Project	<b>IEEE 802.16 Broadband Wireless Access Working Group</b> < <a href="http://ieee802.org/16">http://ieee802.org/16</a> >
Title	<b>Details of SDD Section 11.6 Uplink Physical Structure</b>
Date Submitted	<b>2008-09-05</b>
Source(s)	Fan Wang, Bishwarup Mondal, Mark Cudak, Fred Vook, Bill Hillary, Eugene Visotsky, Amitava Ghosh Motorola E-mail: fanw@motorola.com
Re:	SDD Session 56 Cleanup, Call for PHY Details
Abstract	This is revised version of Section 11.6 of IEEE 802.16m-08/003r4. This document provides further physical layer details.
Purpose	Draft for further development of the IEEE 802.16m SDD
Notice	<i>This document does not represent the agreed views of the IEEE 802.16 Working Group or any of its subgroups. It represents only the views of the participants listed in the "Source(s)" field above. It is offered as a basis for discussion. It is not binding on the contributor(s), who reserve(s) the right to add, amend or withdraw material contained herein.</i>

# The Draft IEEE 802.16m System Description Document

### 11.6 Uplink Physical Structure

[Fig. X: UL LRU pilot patterns for 1, 2 steams and 4 streams](#)

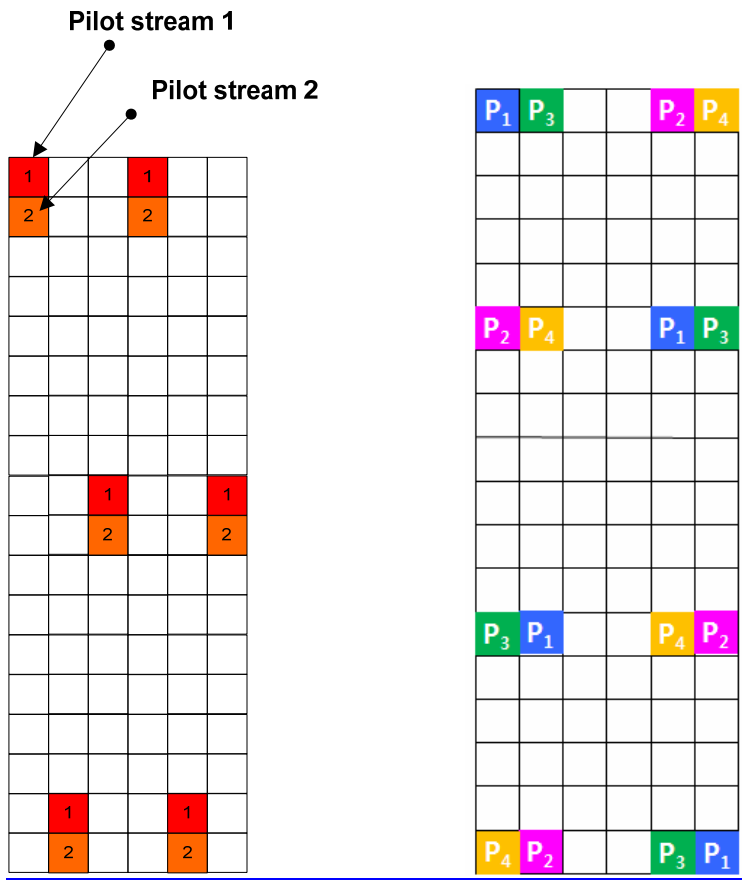
7  
8 The pilot pattern may support variable pilot boosting. The boosting values are TBD. [The UL pilot patterns for](#)  
9 [LRU is the same as DL LRU as shown in Fig. X. The UL pilot patterns for LRU is shown in Fig. Y.](#)
